Access Compliance Report

Public Rights-of-Way

Intersection ID: 13627	Main Street: COMMONWEALTH_AV	Cross Street: WESTOVER_ST	Location: S
ADA ID: 77470E796B8E	Ramp Type: Perp	Initial Pass/Fail: Fail	Overall Compliance: No
Codes/Mitigation Info/Possible Solution		Field Measurements/Component Compliance	
Severity Score: 8.75

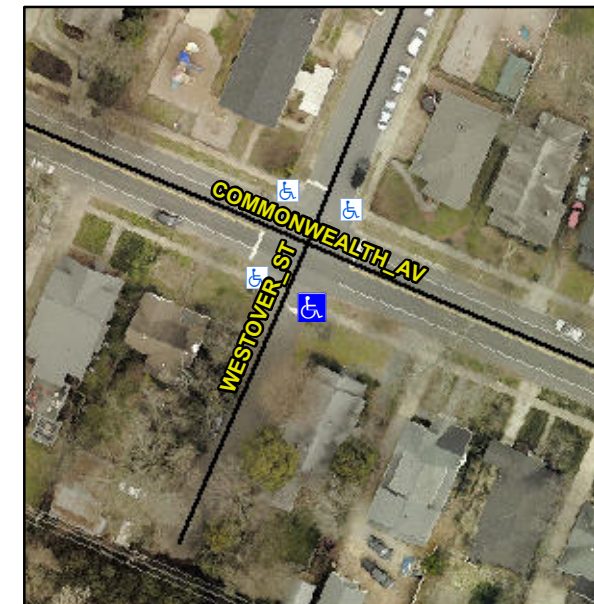
Not Found, R304.5.1

Compliance	Description	Data	Compliance	Description	Data
N/A	Ramp Length (in)	75.5	Yes	Ramp Slope (%)	7.7
No	Ramp Width (in)	46.0	Yes	Ramp XSlope (%)	0.7
N/A	Flare Type LT	N/A	N/A	Flare Type RT	N/A
N/A	Flare Slope LT (%)	N/A	N/A	Flare Slope RT (%)	N/A
N/A	Flare Traversable LT?	N/A	N/A	Flare Traversable RT?	N/A
N/A	Landing Length (in)	N/A	N/A	DWS Provided?	N/A
N/A	Landing Width (in)	N/A	N/A	DWS Contrast?	N/A
N/A	Landing Slope (%)	N/A	N/A	DWS Length (in)	N/A
N/A	Landing X Slope (%)	N/A	N/A	DWS Full Width?	N/A
N/A	Landing Curb? (Y/N)	N/A	N/A	DWS Offset (in)	N/A
N/A	Shared Landing?	N/A			
N/A	Gutter Ponding?	N/A	N/A	Gutter Slope (%)	N/A
N/A	Gutter Lip Ht (in)	N/A	N/A	Gutter X Slope (%)	N/A
N/A	Painted X Walk1?	No	N/A	Painted X Walk2?	N/A
	X Walk 1 Direction	To NW		X Walk 2 Direction	N/A
N/A	X Walk 1 Width (in)	N/A	N/A	X Walk 2 Width (in)	N/A
	X Walk 1 Slope (%)	3.1		X Walk 2 Slope (%)	N/A
	X Walk 1 X Slope (%)	0.9		X Walk 2 X Slope (%)	N/A

Remove & Replace Entire Ramp.
